**CERTIFICATE OF APPROPRIATENESS**

**Property:** 1115 Le Green Street, Lot 17, Block 111, North Norhill Neighborhood Subdivision. The property includes a historic 1,238 square foot, one-story wood single-family residence and detached garage situated on a 5,000 square foot (50' x 100') interior lot.

**Proposal:** Revision to Rear Addition Roof Line

Proposed Site and Roof Plan

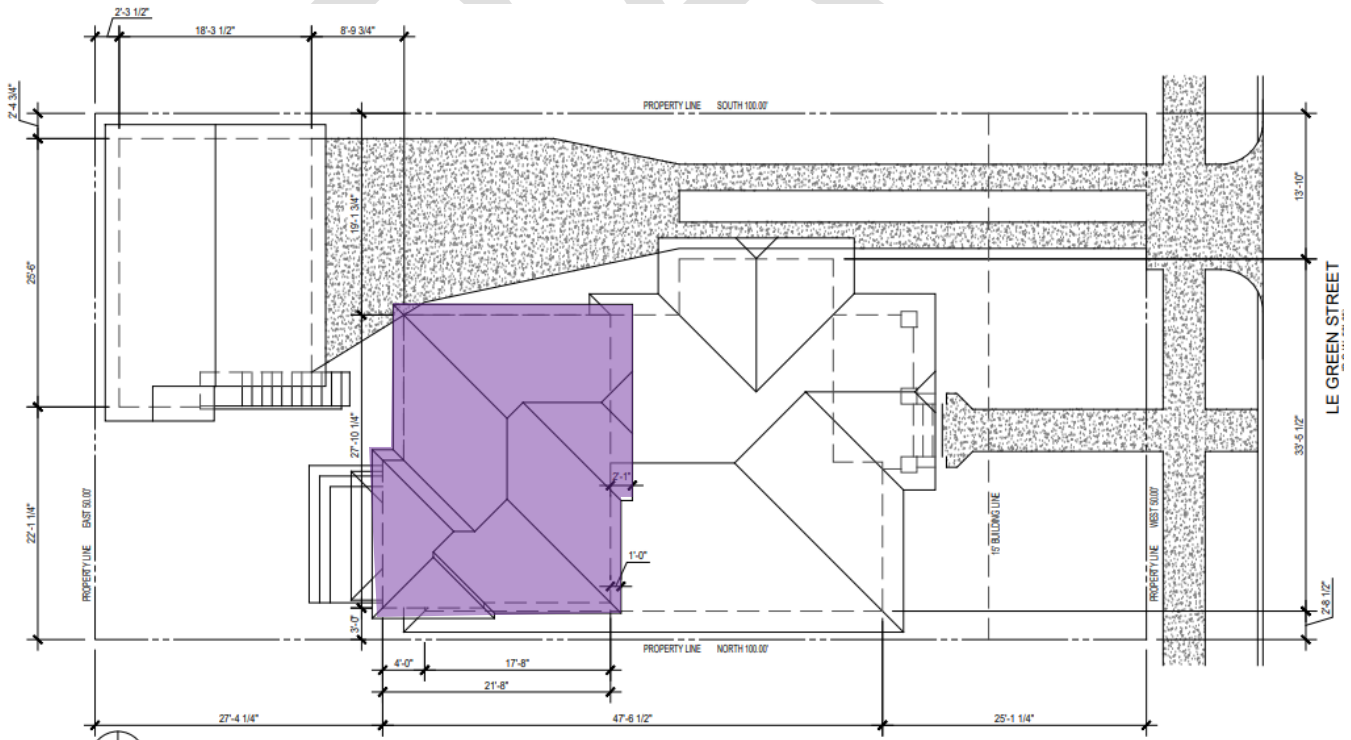
- Change from a hipped roof to a partial gable roof on Front (South) elevation of proposed two-story rear addition

Proposed Front (South) Elevation

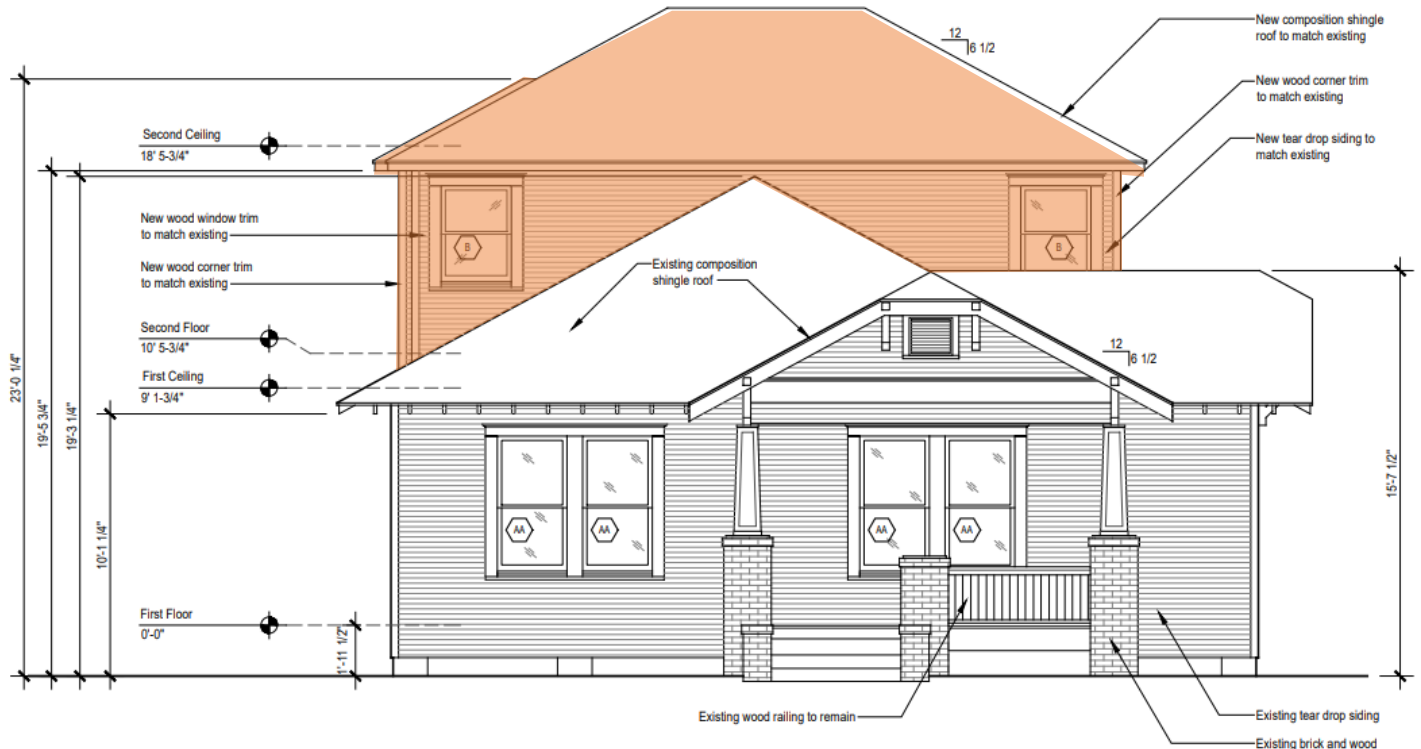
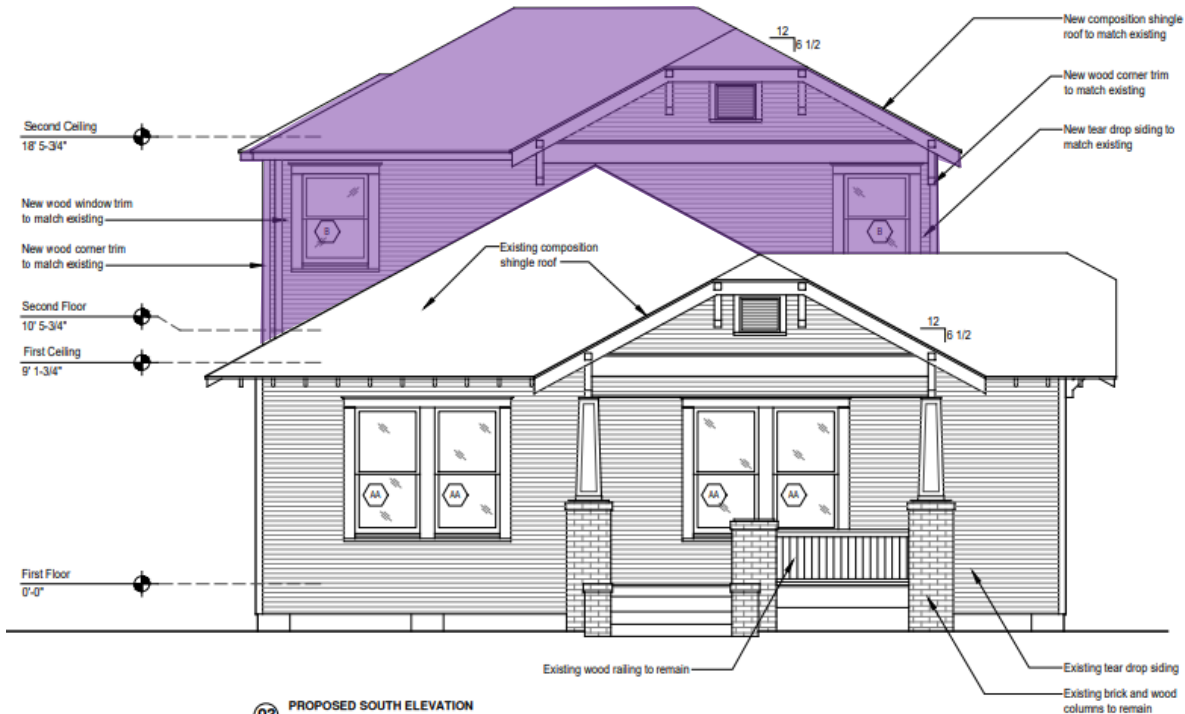
| <input type="checkbox"/>            | <input checked="" type="checkbox"/>                                 | <input type="checkbox"/> | (3) The proposed activity must recognize the building, structure, object or site as a product of its own time and avoid alterations that seek to create an earlier or later appearance; <b>the front gable on proposed second story rear addition with the vent, brackets, and fascia board creates an earlier appearance as it mimics the front porch details.</b> |

<p><b>Recommendation:</b> Approval with conditions: Removal of vent, brackets, and fascia board from proposed front gable on second-story rear addition</p>
---
